RECORD OF DECISION

Bausch & Lomb

Frame Center Site

Site Number 8-28-061

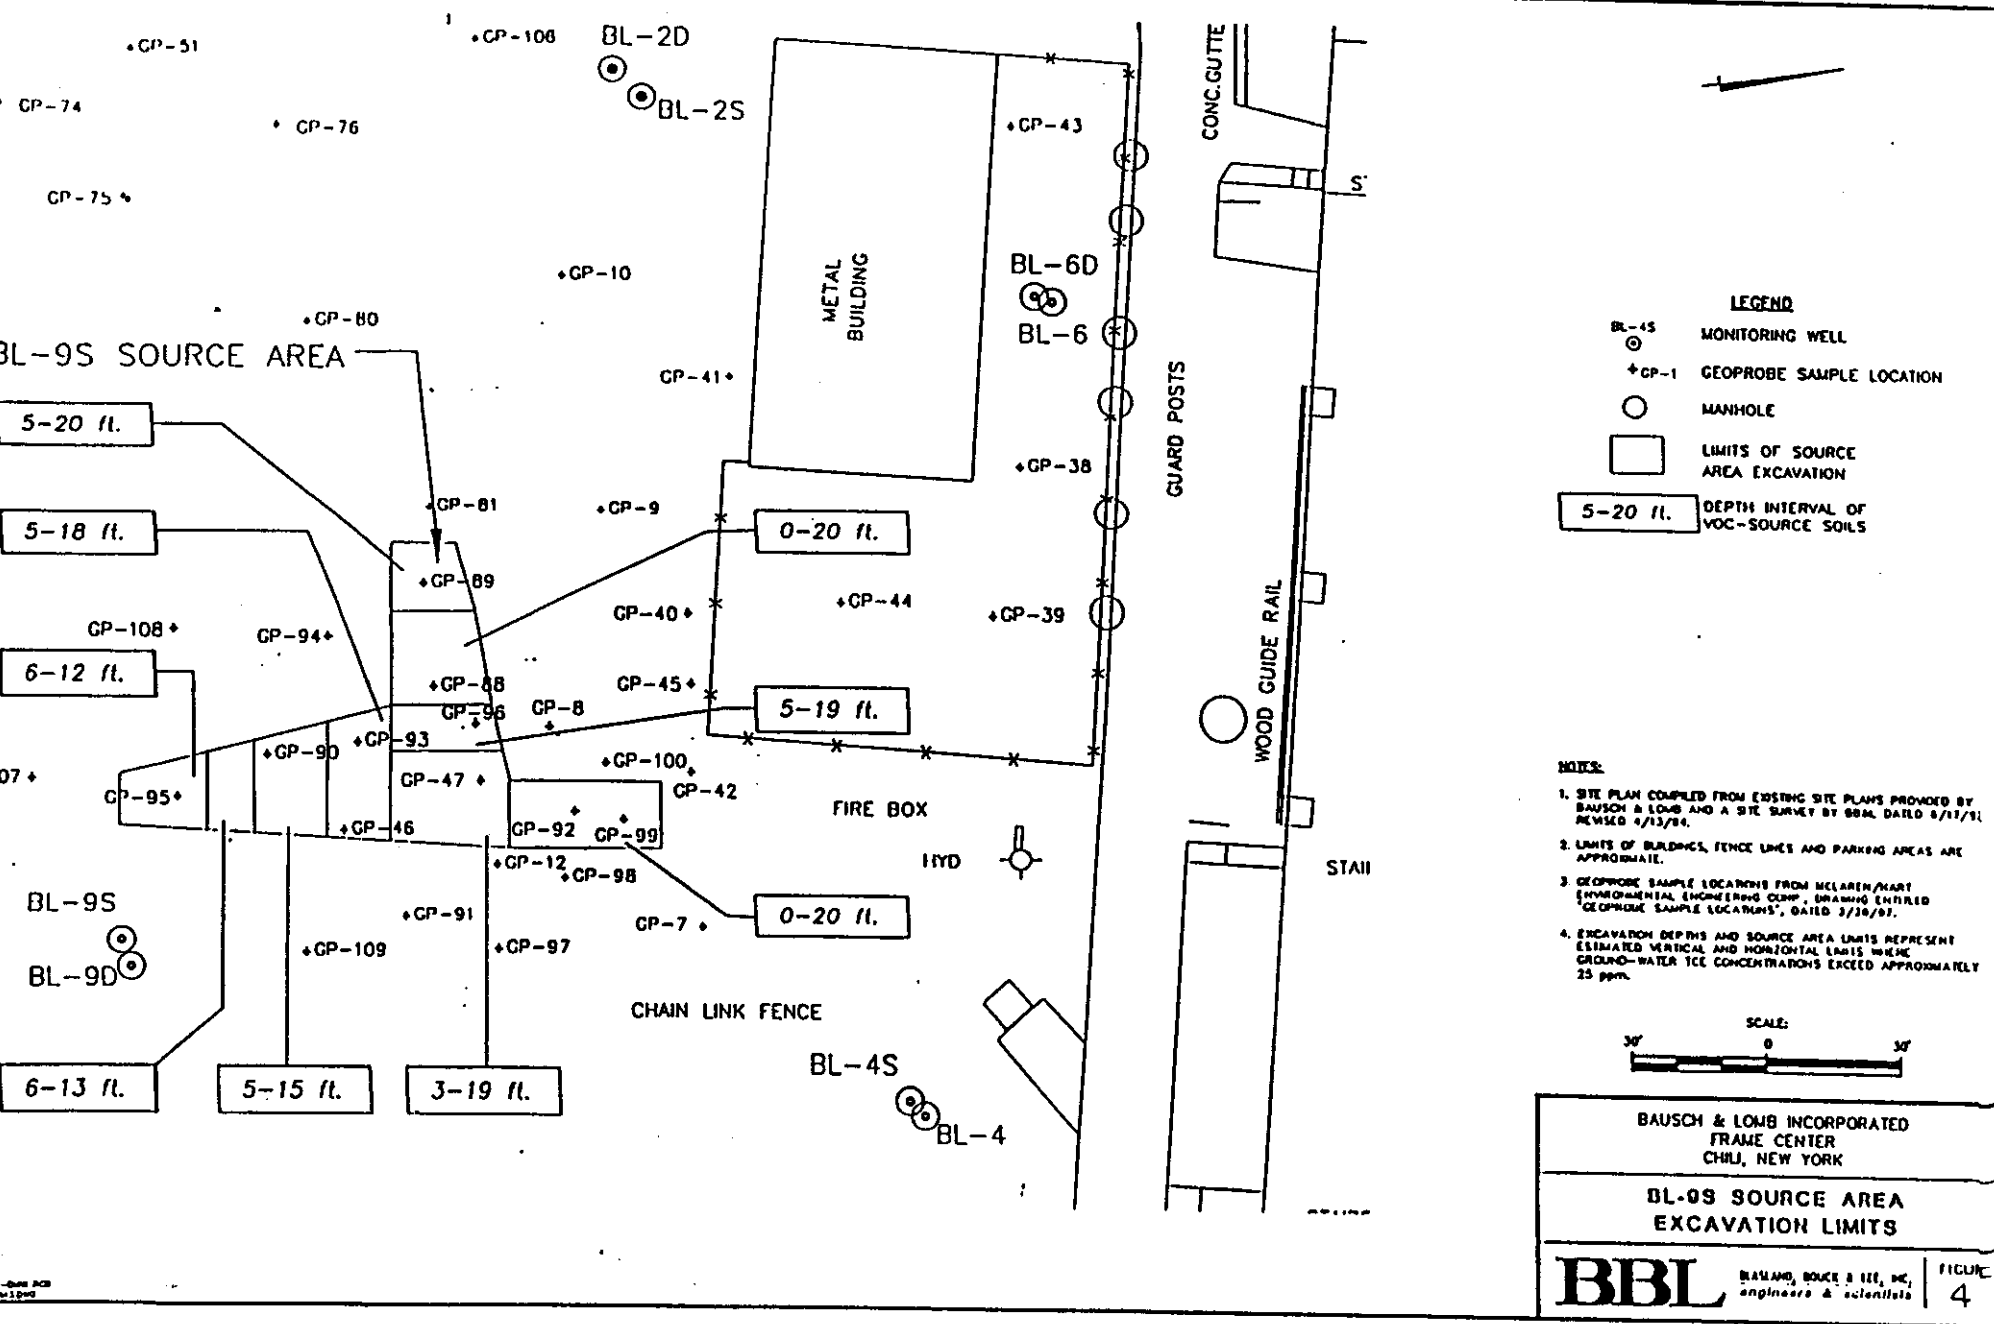
Question 3: For the plumes as delineated on the map, is that their complete extent?

Question 20: Do you have a map to show locations of contamination on Bausch & Lomb property compared to the location of residential properties near by? I want to know how close the contamination is to nearby houses.

Answer 3: The complete downgradient extent of the BL-16S plume and the BL-9S plume have not been fully defined. As shown on Figure 3, the southern and southeastern extents of these plumes have not been defined. Part of the pre-design field investigation (see Section 7: Summary of the Selected Remedy) will address the limited data gaps and provide additional VOCs data necessary to confirm the limits of the source areas requiring excavation.

Answer 20: Figure 3, in the ROD, shows the three groundwater plume areas and the chain link fence which approximates the western boundary of the site.
